COOPER NUCLEAR STATION

AMENDMENT TO FACILITY OPERATING LICENSE

Amendment No. 87
License No. DPR-46

ATTACHMENT TO LICENSE AMENDMENT NO. 87

FIGURE 2.1.1
REACTOR WATER LEVEL INDICATION CORRELATION

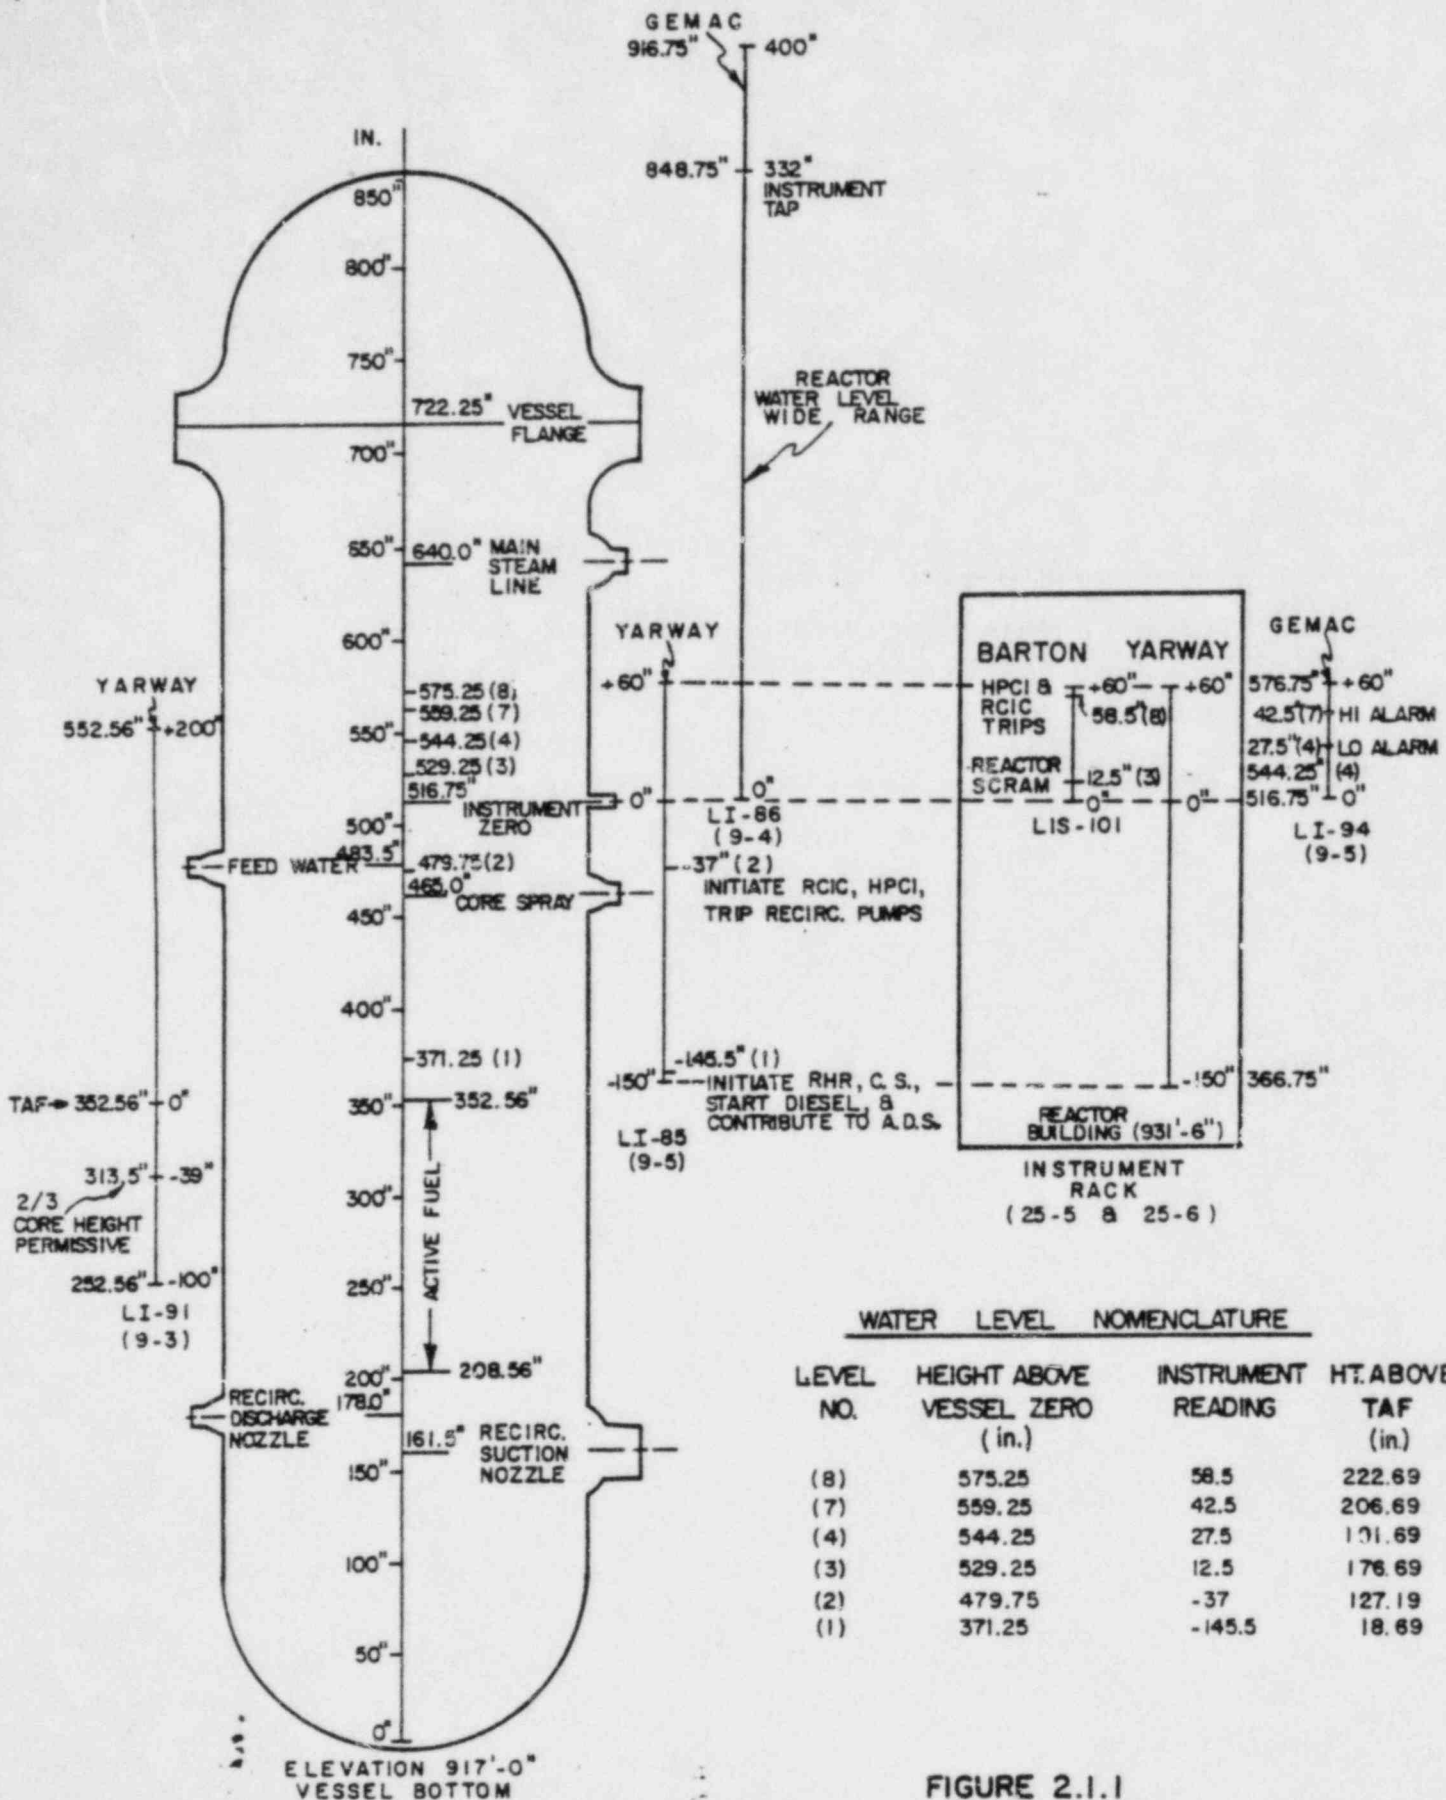
Revise the Appendix A Technical Specifications as follows. The revised areas are indicated by marginal lines.

LEVEL NO.	HEIGHT ABOVE VESSEL ZERO (in.)	INSTRUMENT READING	HT. ABOVE TAF (in.)
(8)	575.25	58.5	222.69
(7)	559.25	42.5	206.69
(4)	544.25	27.5	171.69
(3)	529.25	12.5	176.69
(2)	479.75	-37	127.19
(1)	371.25	-145.5	18.69
